STAFF REPORT: 10/12/2022 REGULAR MEETING

APPLICATION NUMBER: #22-8066

ADDRESS: 2011 LONGFELLOW

SCOPE: REPLACE WOOD WINDOWS WITH WOOD AND FIBERGLASS UNITS ALTER PORCH
(WORK COMPLETE WITHOUT APPROVAL)

Fig 1, by Applicant: Proposed adhesives for applying wood grid to existing fiberglass window installation.

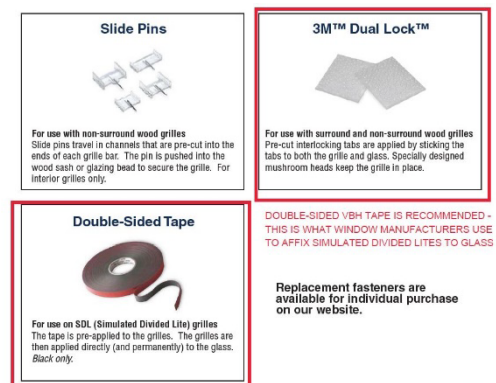
- It is staff’s opinion that the application of wood muntins on fiberglass windows is not an appropriate application of materials as it attempts to disguise rather than restore historic character-defining features, especially the operation and design of the original ribbon of wood, double-hung windows that were replaced by picture windows. However, staff observed that the application of these muntins occurs in locations of the house that are not as publicly visible, with the exception of windows 23 and 18, which staff noted earlier, is publicly visible.

- The installation of built-in screens, with the darker fabric tints the windows further and is inappropriate.
- The application of wood muntins on glass and fiberglass with adhesive tape is not appropriate.

Fig 2, by Applicant: Proposed window schedule, showing the reverting of large picture windows back to the double hung windows at the rear and side (west) elevations and retention of historic windows (blue), replace fiberglass with aluminum clad wood (red), and retaining fiberglass windows (green).

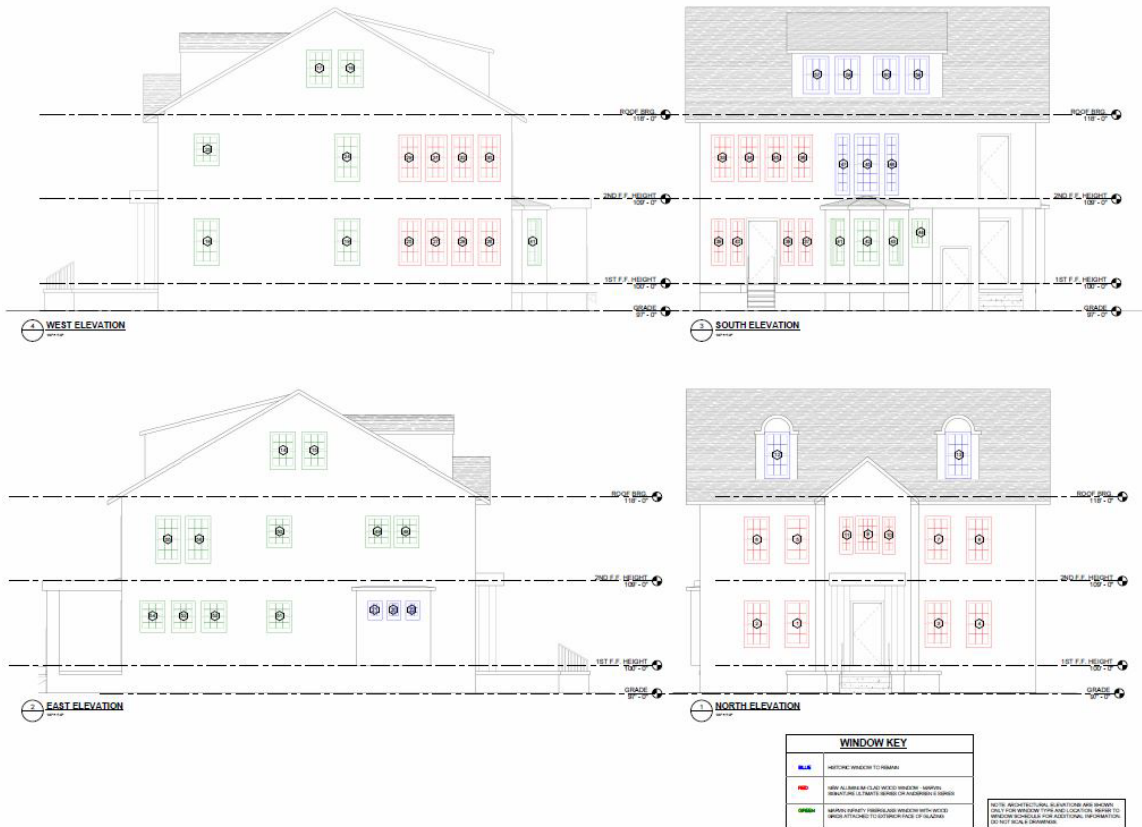
- Staff has confirmed that the total number of original wood windows replaced is 48 units.
- In the November 2021 HDC Regular Meeting, the Commission determined that the replacement of the original windows with fiberglass sash was issued a denial for these same fiberglass windows that are proposed to remain. The Commission has already denied the application for these windows in the November 2021 HDC Regular meeting. The part that is different is the application of the wood muntins to these remaining windows to the exterior of the glass.

- Staff has identified that the divided light double-hung windows, and their ribbon formation on the west and rear elevations, are distinctive character-defining features that have been removed without approval, and therefore substantially detracts from and destroys the historic appearance of the building.

- It is staff's opinion that replacement of picture windows (that had previously replaced original double-hung windows) with double-hung windows on the rear and west elevations is appropriate in type and scale as it mimics the original historic, character-defining features of this ribbon formation that was lost when the original windows were removed.

It is staff's opinion the installation of the proposed aluminum-clad windows is a reasonable and feasible solution to restore the design, operation, and configuration of the original windows, thus not greatly altering the features and spaces that characterize the property. Additionally, the removal of the planter boxes to protect the house and the proposal to treat the scarring and conceal the scarring with foundation plantings are sympathetic to the historic features of the house. Staff therefore recommends the Commission issue a Certificate of Appropriateness for the work as proposed because it meets the Secretary of the Interior Standards for Rehabilitation.

Fig 4, by Applicant: (North) front side plan showing current built conditions and installed handrail elevations for the front steps, work complete.

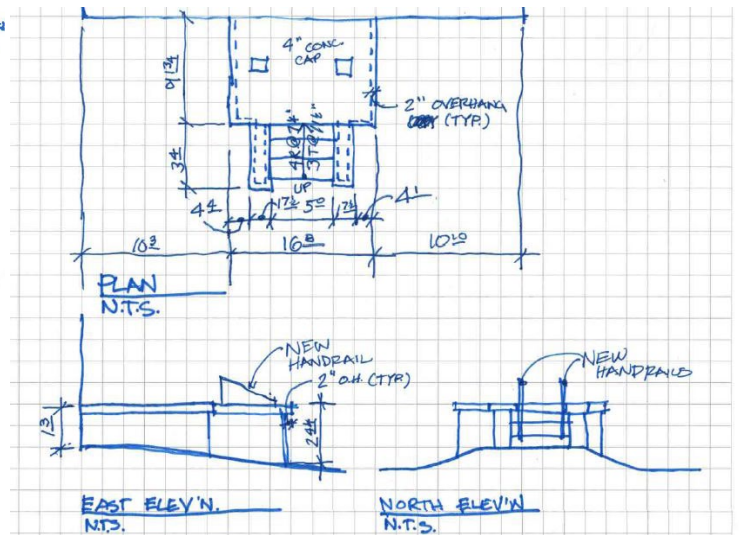
- Currently, the brick planters have been removed, leaving scars on the face of the house, and the concrete porch is complete at a lower elevation than the original as evident by the “floating”

- While the porch has undergone several changes and iterations in its configuration over time, it is staff's opinion that the relationship of the curvilinear roof of the front porch, its columns, and its clear architectural relationship to the original curvilinear steps were distinct, character-defining features of this house that have since been altered or destroyed. It is staff's opinion that the wing-walls of the current steps, especially severs this curvilinear relationship of the front elevation of this house and is inappropriate.

- The height of the 38" handrails exceed the 24" height of the step's wingwalls, creating a scale issue with the railing to the steps in staff's opinion.

Site Photo 7, by Staff: (West) side elevation showing thick, aluminum coil stock around brick mold and seam, and aqua tinted double-hung window (#18), proposed to remain.

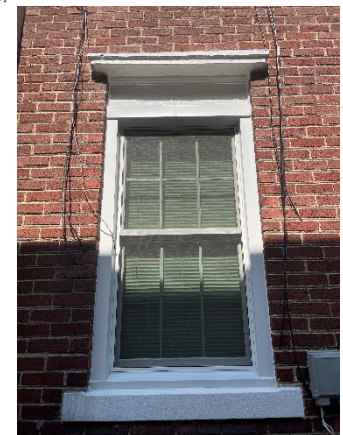
- Staff observed that the installed fiberglass windows have several features that are not appropriate. These larger changes to the original wood windows greatly outweigh the changes in the proposed attempt to add attached grids to the exterior of the windows:

- the surrounding coil covering the brickmold is large and gives the windows a chunky appearance and with the picture windows, larger seems are found around the perimeter,

- the meeting rails in the double hung windows do not meet,
 - the dimensions of the header and base of the window do not match the original wood windows,

- the color of the glass is tinted green/aqua color, and
 - the built-in screens are shadowed, casting a darker shade across the windows.
